## **Response to Public Comments on 8/18/09 Review of Potential Selenium Issues Following a Coal Ash Spill at the Tennessee Valley Authority (TVA) Kingston Fossil Plant**

**December 2009**

Figure 1

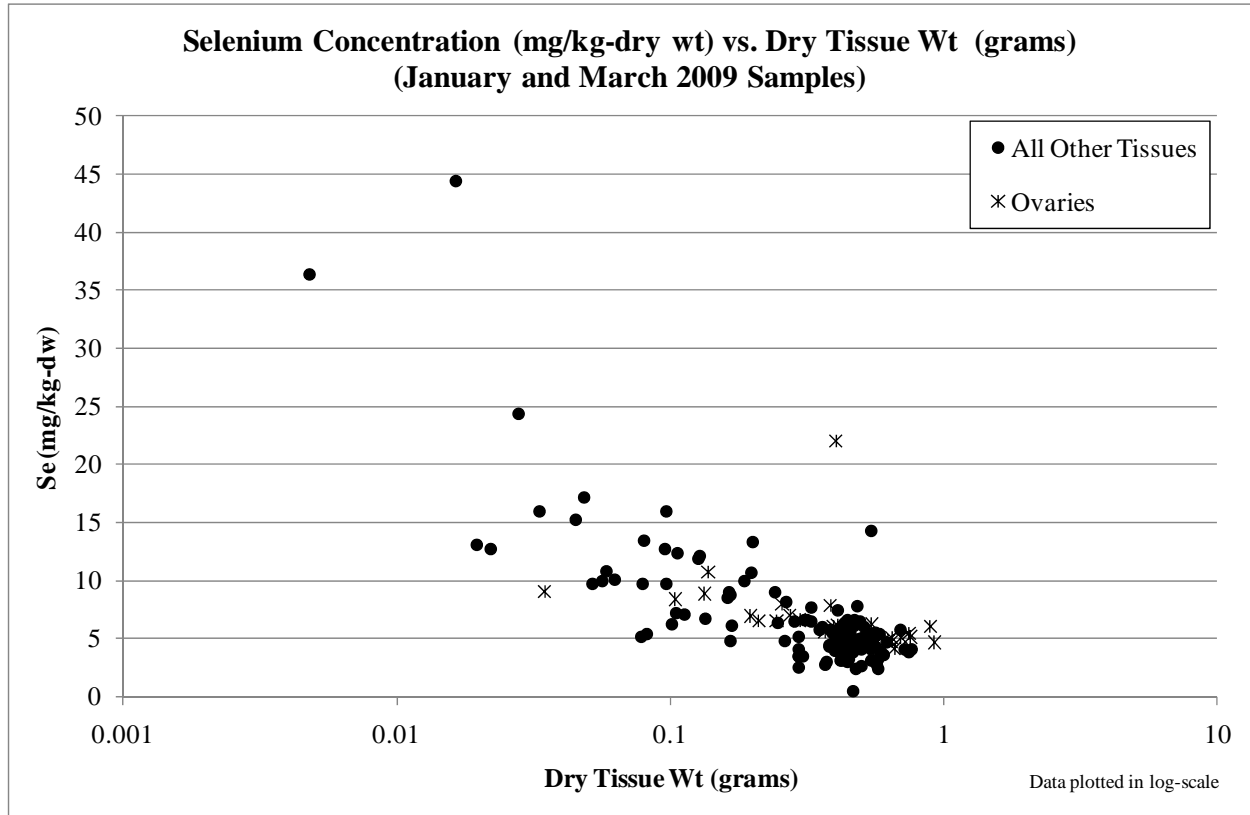
4. All results in which the digestate concentration is less than 200 ug/L should be flagged as inconclusive (the only potential low concentration verification check sample would be the LFB, which is spiked at a concentration of 200 ug/L).

5. All remaining results should be flagged as estimated.
